State of Utah
Department of Transportation

February 26, 2003

SUBJECT: STP-0108(7)3
Syracuse Road; Main Street to 1000 W, Clearfield
Addendum No. 1

SHEET NO. DU-1

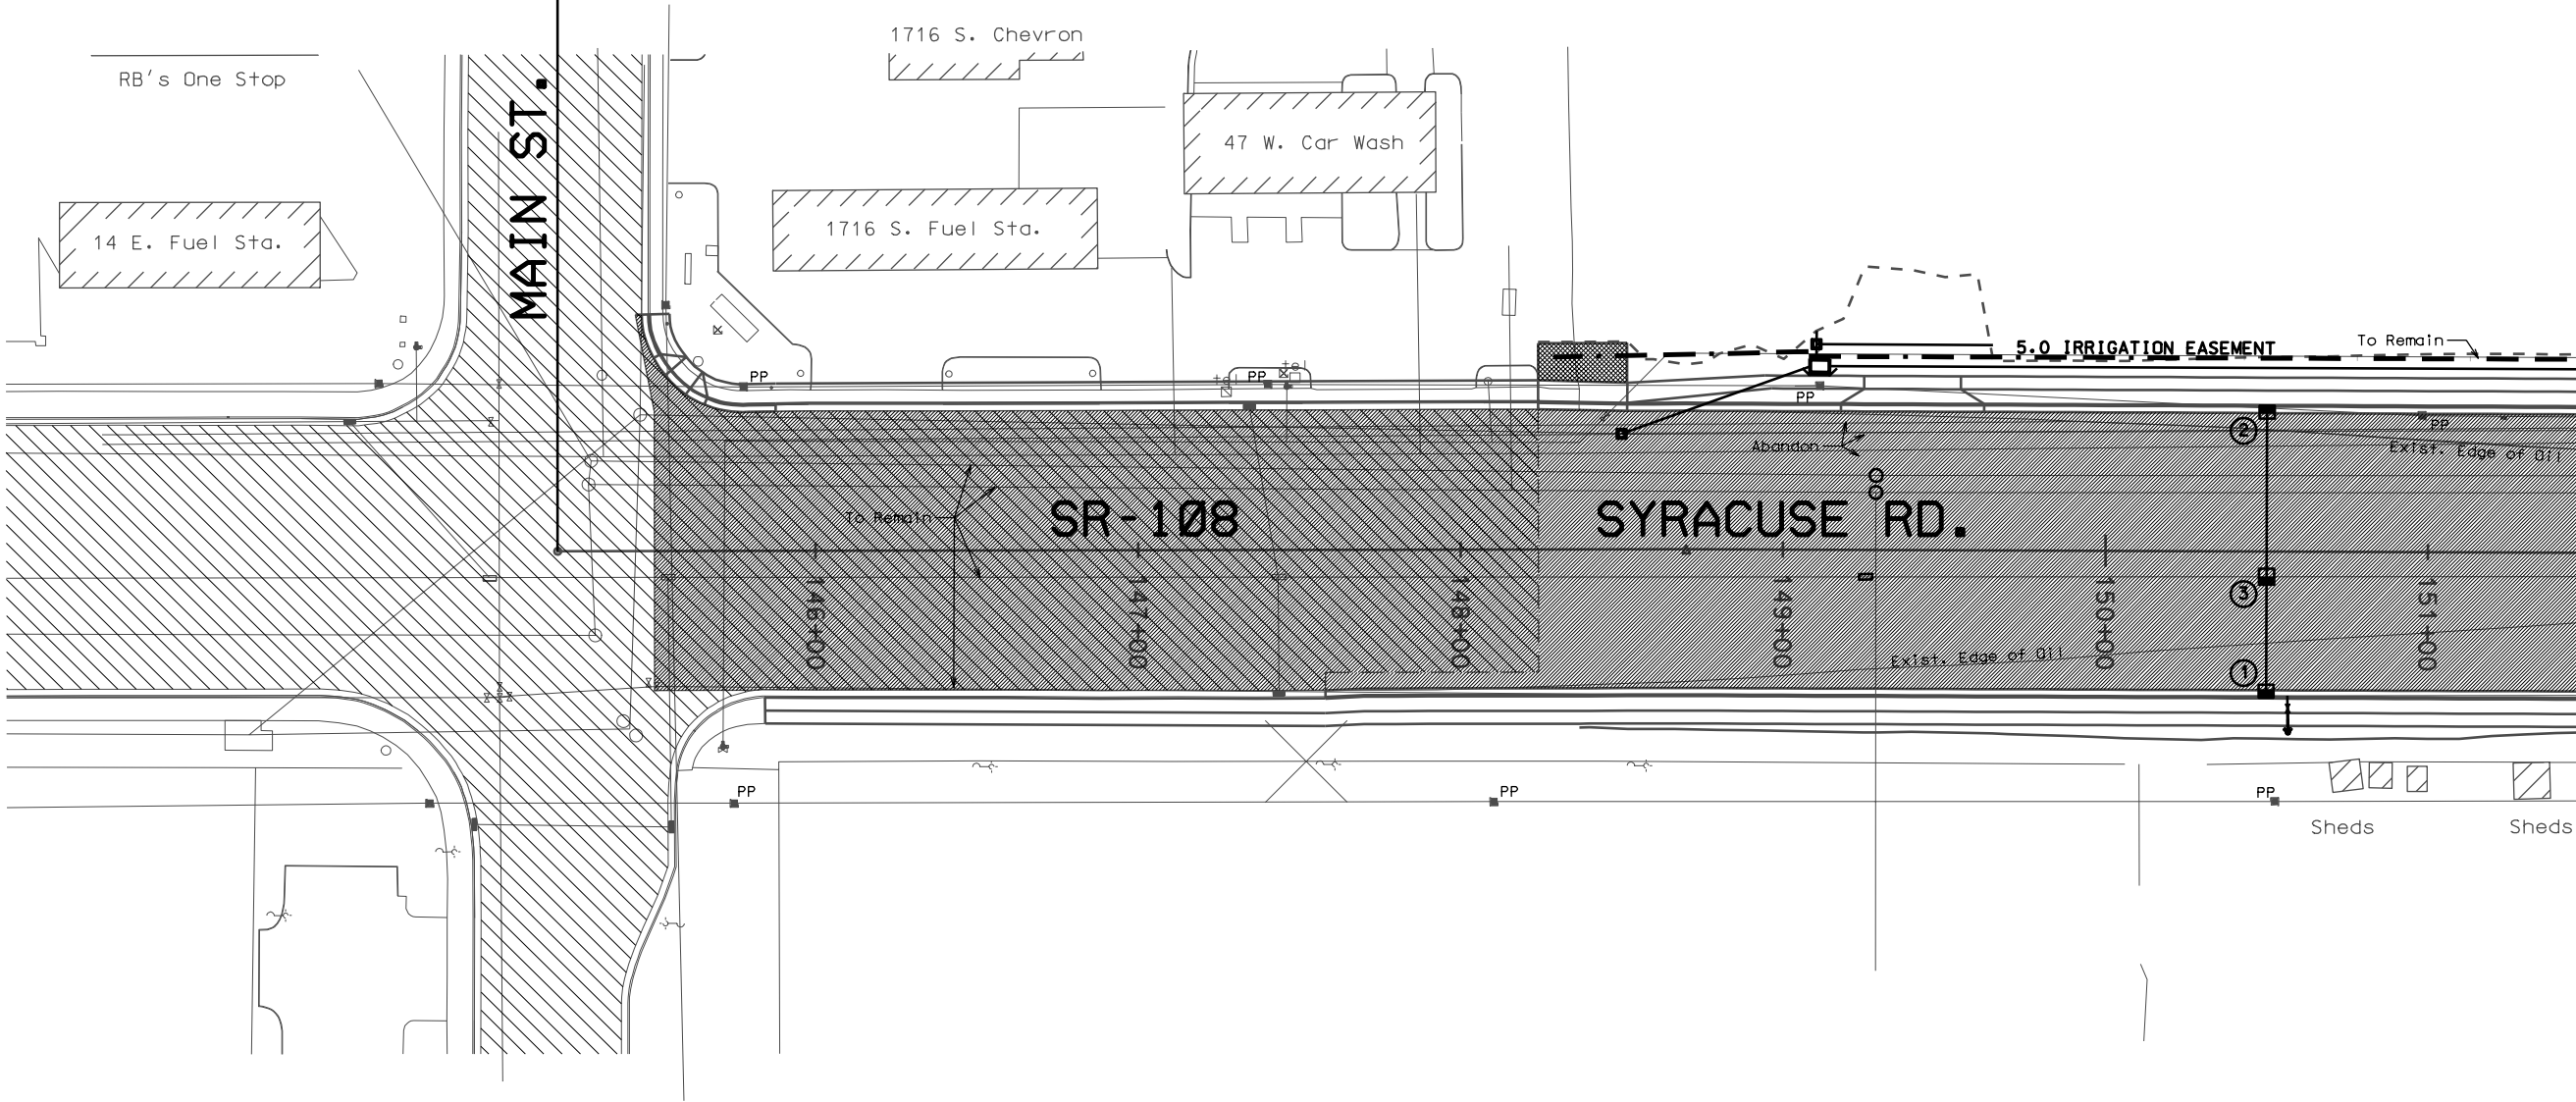
1. The "Table of Contents" has been revised.
2. The "Measurement and Payment" has been revised.
Item 023160020 Roadway Excavation on page 5 of 16 has been revised.
3. Standard Specification **02969 Optional Use of Reclaimed Asphalt Pavement** has been deleted.
4. Special Provision **00725 M Scope of Work** has been revised.
5. Special Provision **00727 M Control of Work** has been revised.
6. Special Provision **02741 M Hot Mix Asphalt (HMA)** has been added.
7. Special Provision **02969 S Optional Use of Reclaimed Asphalt Pavement** has been added.
8. Plan Sheet DU-1 has been revised.
